Re: Final Plat S/D 87-104 - ATKISSON ADDITION

Re: Preliminary Plat S/D 87-104 - ATKISSON ADDITION

STAFF REPORT  
(Final Plat; Preliminary Approved 10/22/87)

CASE NUMBER: S/D 87-104 - ATKISSON ADDITION

VICINITY MAP:

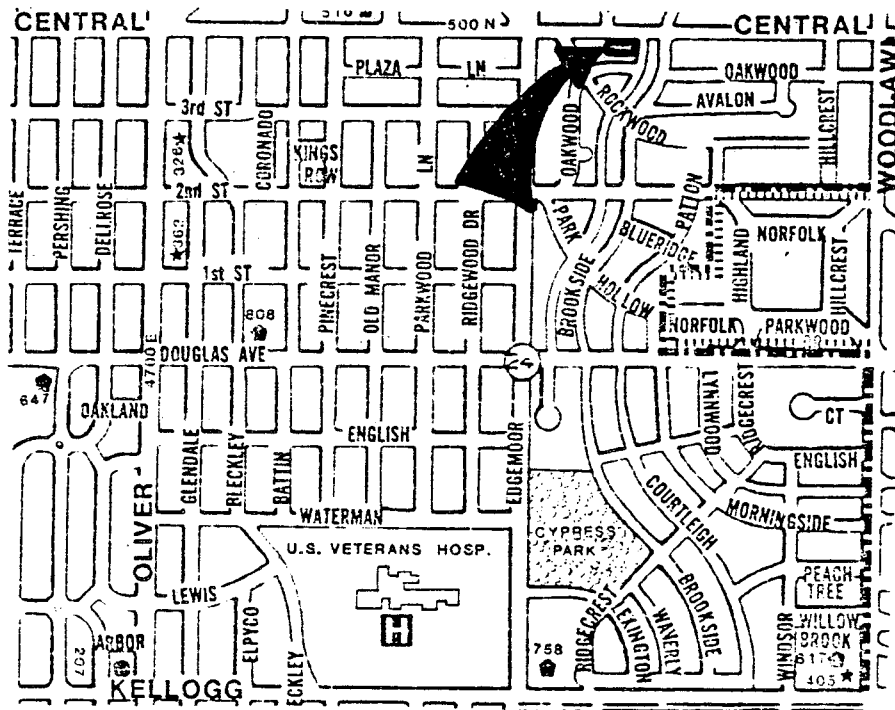
- A. The applicant shall guarantee the storm sewer improvement within public right-of-way that is required by the platting of this property.
- B. The applicant shall guarantee the closure of the two driveways on Lot 1 that are in excess of the access control being platted. A guarantee shall be submitted which guarantees the closure of one driveway from Lot 2. Separate guarantees shall be submitted for each lot.

- D. When the preliminary plat was reviewed by the Subdivision Committee and the full Planning Commission, a joint access drive was depicted on the lot line common to the two proposed lots. This joint access drive was also depicted on the parking layout plan required by the City Council in connection with the Council's approval of the associated zone cases.

The final plat tracing shall indicate the joint access easement which was depicted on the preliminary plat. This joint access easement will need to be established by separate instrument with appropriate recording information indicated on the final plat tracing. Prior to recording the joint access easement, a draft shall be submitted to the Planning Department for review and approval. The instrument must clearly state the purpose of the easement as well as which properties benefit from the easement. Initial construction responsibilities and future maintenance of the driveway within the easement should also be addressed by the text of the instrument.

- F. On the final plat tracing, the half street right-of-way available for Central adjacent to this plat shall be indicated.
- G. Prior to scheduling this plat for City Council review, the applicant shall submit the covenant required by the City Council during approval of the associated zone cases. This covenant disallows expansion of office and office-commercial uses onto the property to the south of this plat.

- H. The applicant shall submit for recording the cross lot drainage agreement required by the drainage plan for this property. This agreement shall make reference to the "approved drainage plan" for this property. The drainage agreement shall not only alert future owners of Lot 2 of their responsibility to accept storm waters from Lot 1, but also of the fact that redevelopment of rear yard parking facilities on Lot 1 may not be possible until similar facilities have been constructed on Lot 2.

- K. Perimeter closure computations shall be submitted with the final plat tracing. Section 5-101(C).
- L. Recording of the plat within 30 days after approval by the City Council.

VICINITY MAP:

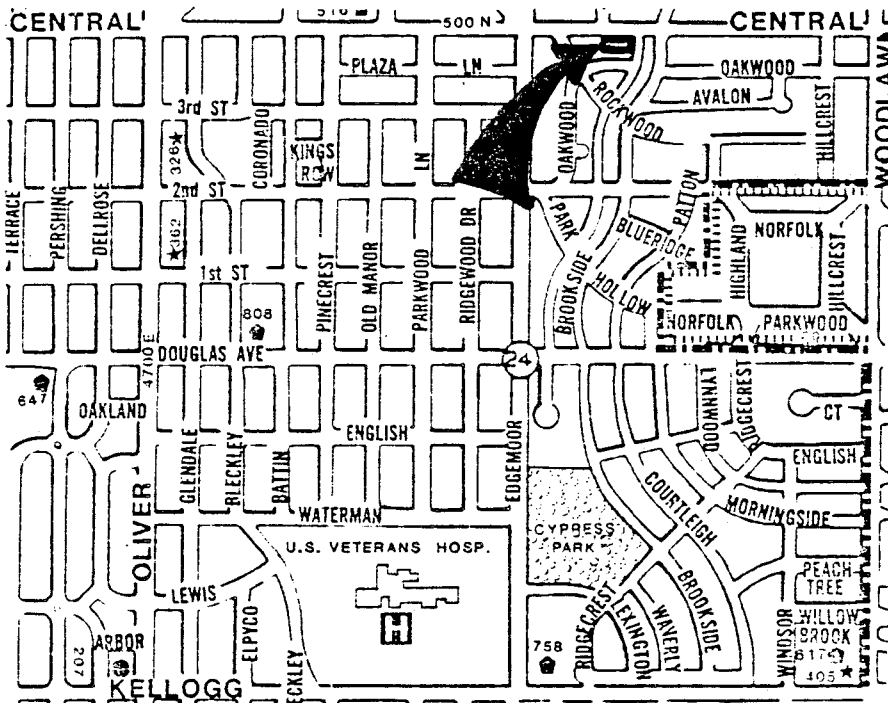
- C. The applicant shall guarantee the closure of the two driveways on Lot 1 that are in excess of the access control being platting. A guarantee shall be submitted which guarantees the closure of one driveway from Lot 2.

- E. The proposed joint access easement on Lot 1 and Lot 2's common lot line will need to be established by separate instrument with appropriate recording information indicated on the final plat tracing. Prior to recording the joint access easement, a draft shall be submitted to the Planning Department for review and approval. The instrument must clearly state the purpose of the easement as well as which properties benefit from the easement. Initial construction responsibilities and future maintenance of the driveway within the easement should also be addressed by the text of the instrument.

- F. On the final plat, the centerlines of the perimeter streets shall be labeled.
- G. A requirement of the associated zone cases was for a parking plan to be submitted with the preliminary plat. It is noted that the preliminary plat depicts the location of the number of off-street parking spaces that can be provided on each lot. The following table states this information along with the total square footage of existing structures as well as the number of off-street parking spaces required to serve the existing buildings.

- H. On the final plat, a 20-foot building setback shall be indicated from Central on Lots 1 and 2. A 15-foot sideyard setback shall be indicated from Brookside Parkway on Lot 2.

- I. On the final plat, "access control except for one opening per lot" shall be indicated to Central Avenue across the north line of this plat.
- J. On the final plat, the plattor's text shall make appropriate reference to K.S.A. 12-512(b).

- P. The City Engineer's representative shall be prepared to comment on whether or not there is a need for a decel lane to serve the proposed driveways.
